Borough of Rumson

APPLICATION TO THE ZONING BOARD OF ADJUSTMENT

Denial Memorandum

Memorandum – Statement of Variances Review

DATE	11/20/25
DRAWN BY	JM
SHEET NO.	V-1

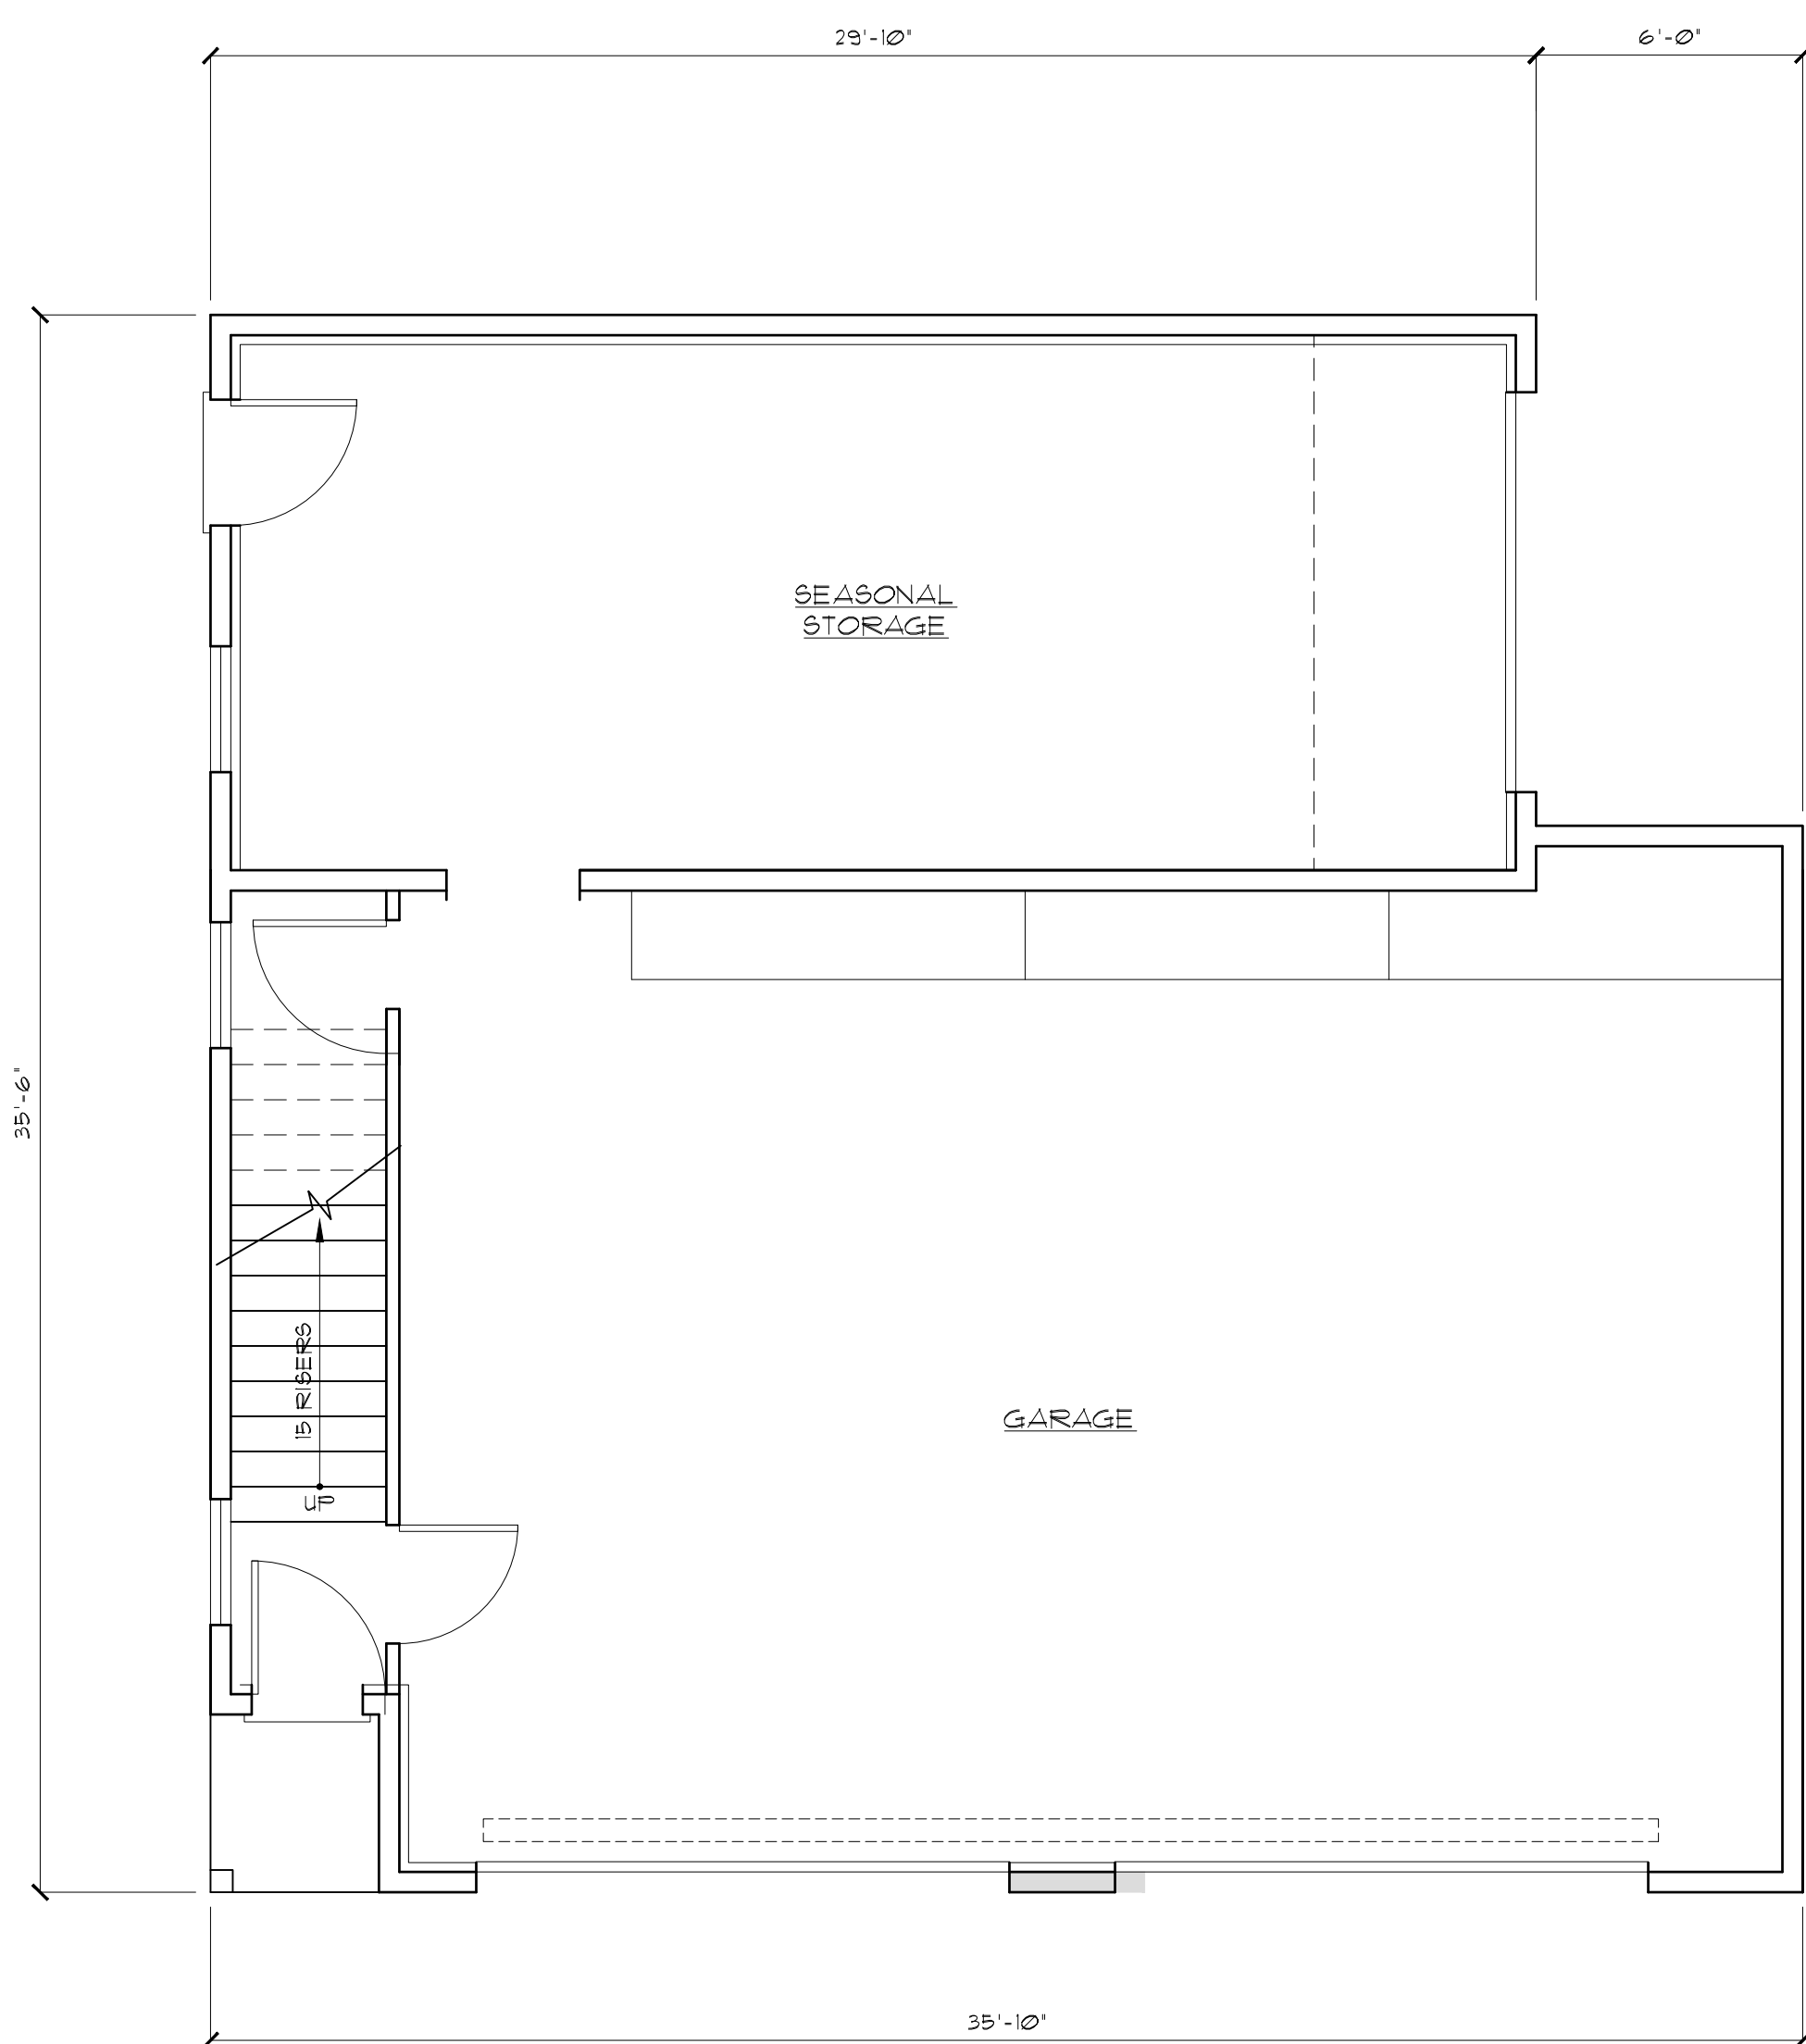
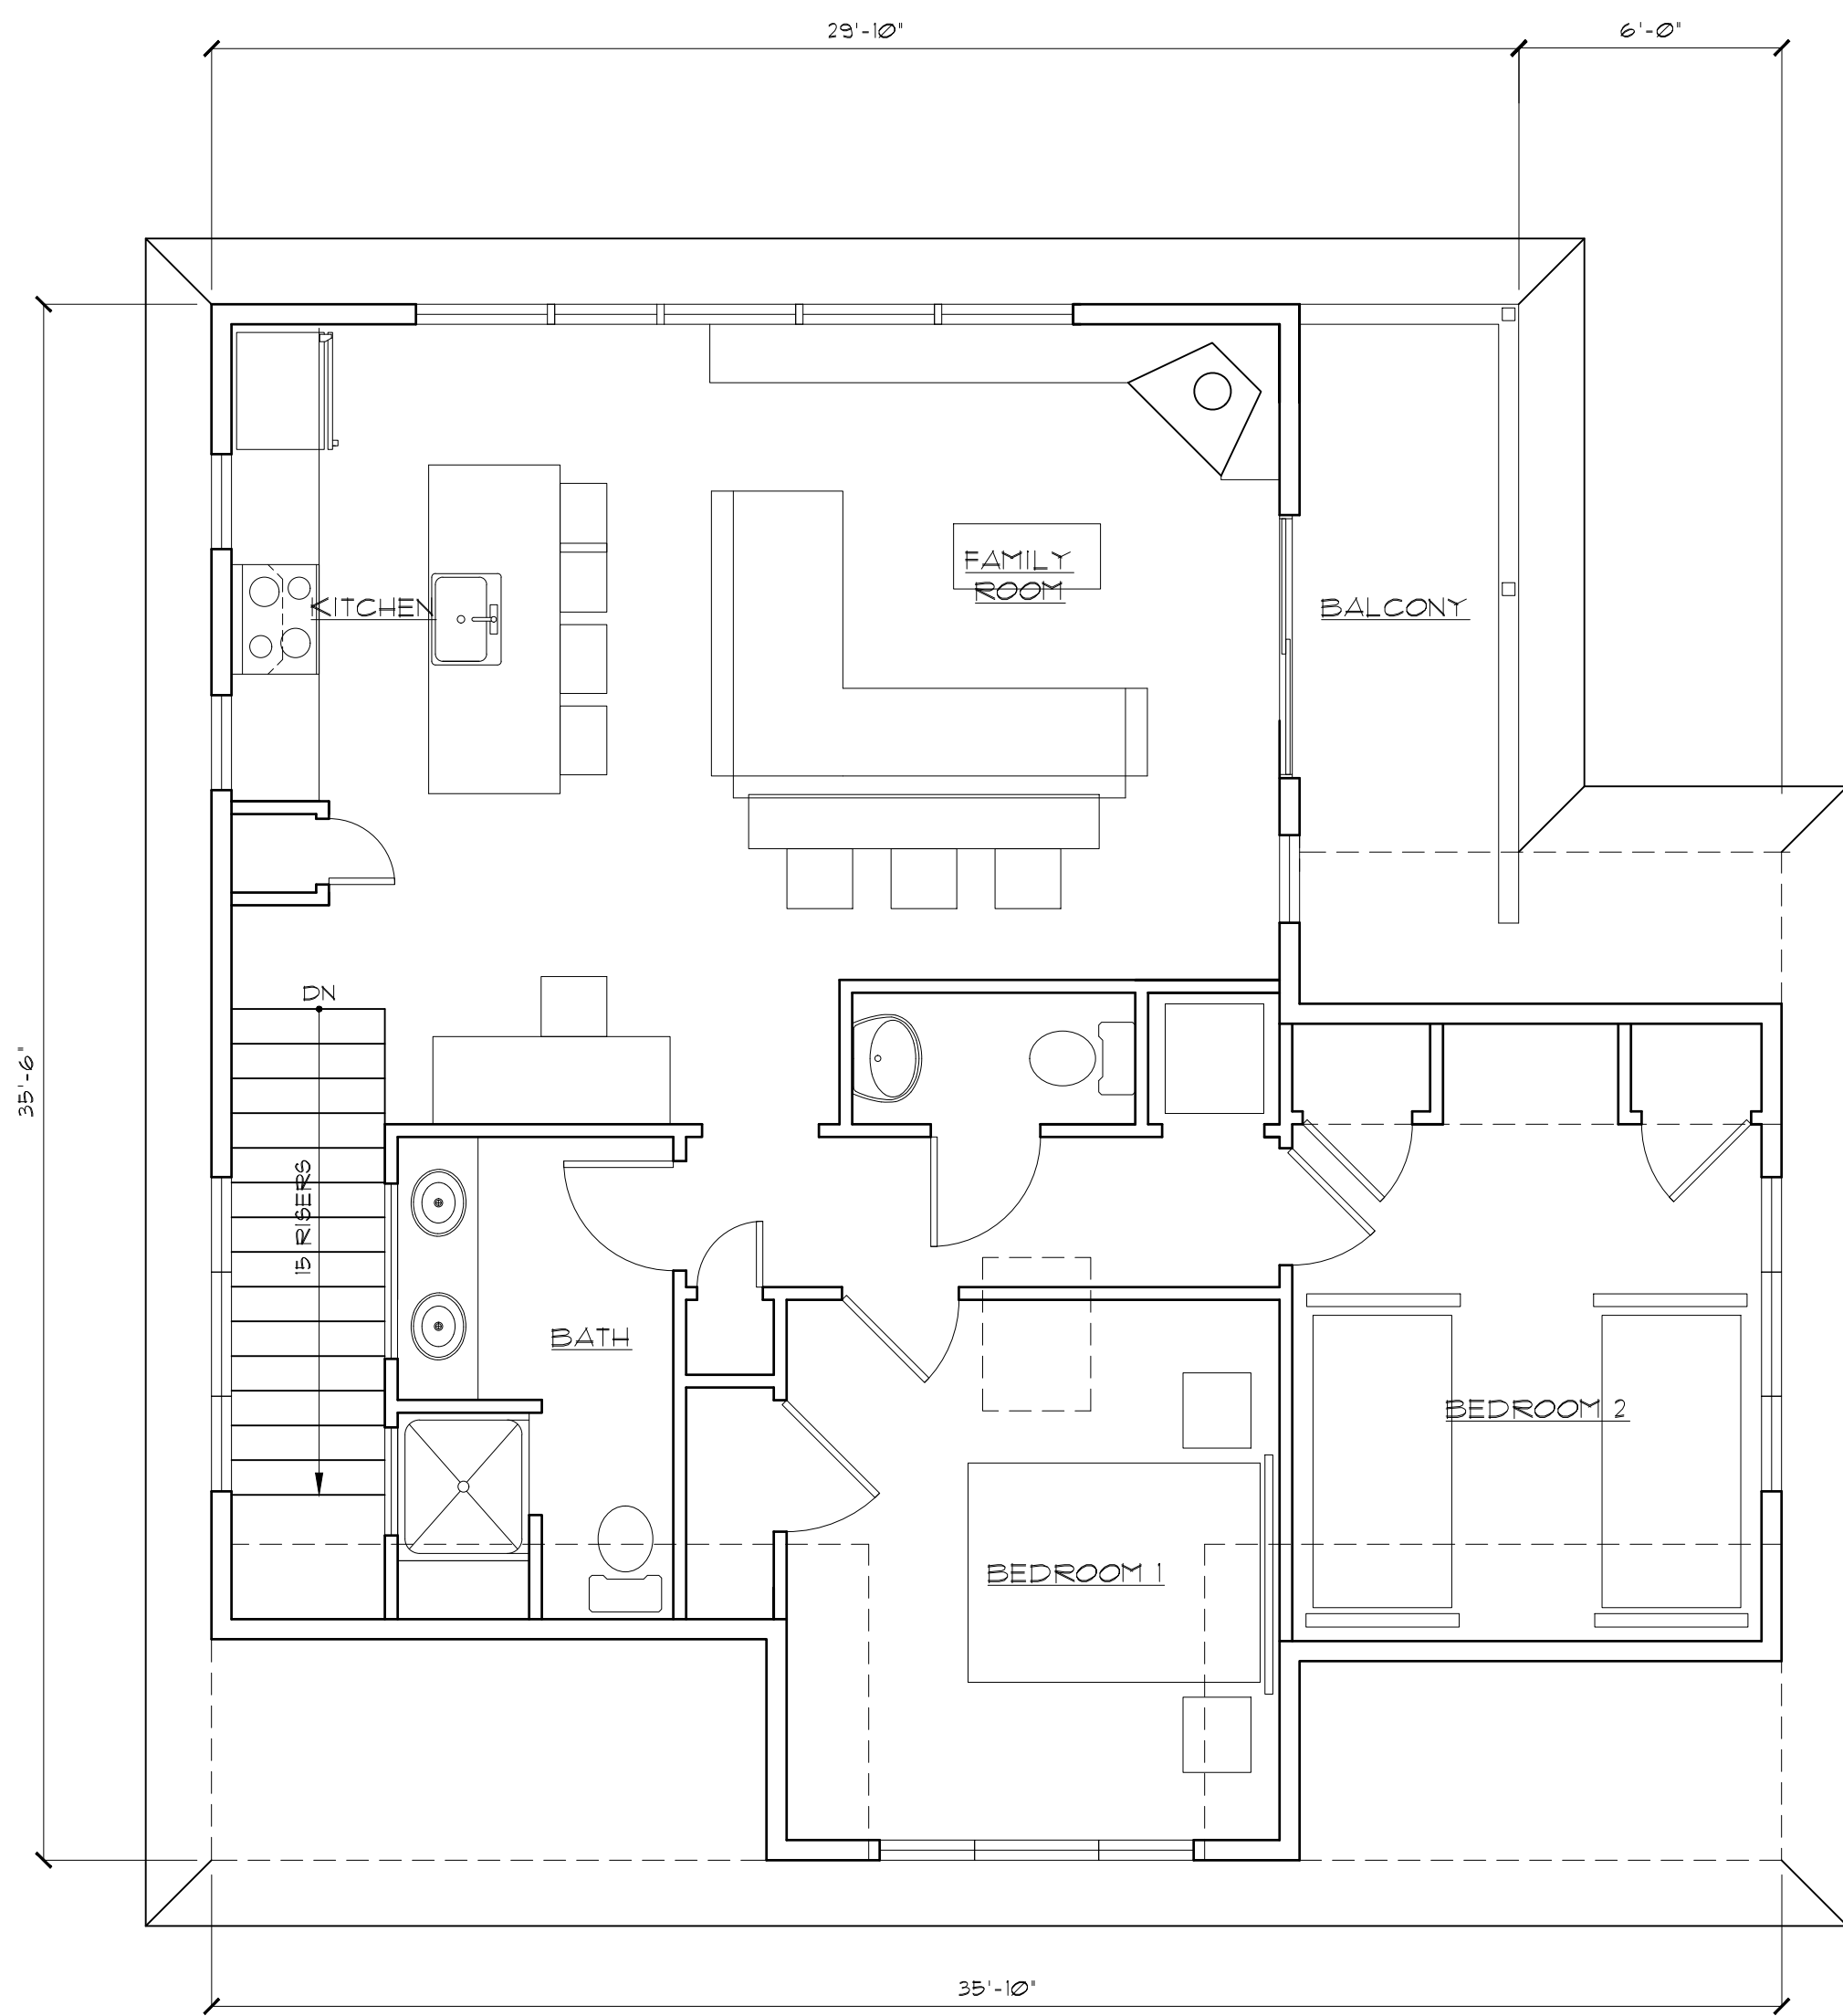
The architectural plan revised to May 6, 2026 includes changes to the width, depth, gross floor area, volume, height and footprint. Those changes are summarized in the table below.

Previous Plan	Current Plan	Note
Height	24 feet	23.5 feet	
Ground Floor Elevation	8.5 feet	7 feet	
Habitable Square Footage	921 square feet	822 square feet	
Volume	26,552 cubic feet	23,662 cubic feet	
Building Width	38 feet	35'-6"	
Building Depth	37 feet	35'-10"	
Building Coverage (All Structures)	6,401 square feet	6,281 square feet	Change eliminates a variance
Footprint	1,323 square feet	1,203 square feet
